**Car Stereo
Service Bulletin**

Model: CDX-A100

No. 181

Subject: No Operation and No Eject
("E99" Is Indicated)

Fig. 1.

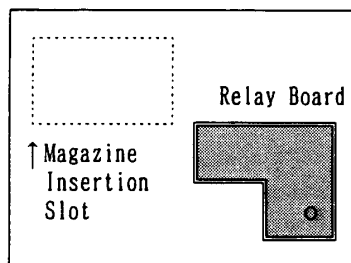
The unit neither operates nor ejects ("E99" is indicated). This happens when the Relay Board touches the MD Chassis and the M1 Motor will not turn.

1. Remove Rear Case.
2. Remove Case Assembly.
3. Remove Upper Case Assembly.
4. Pull out all the connectors of the Relay Board, and unscrew and take out the Relay Board (Fig. 1).

Solution: If this symptom occurs, please attach a cushion to the Relay Board for insulation.

Fig. 2.

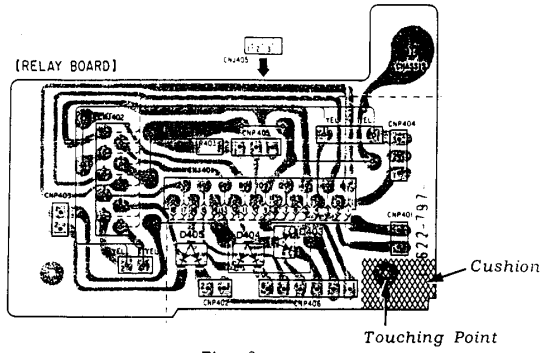
5. Attach a cushion to the spot marked  on the Relay Board (Fig. 2).

Description	Part Number
Cushion	3-831-441-11
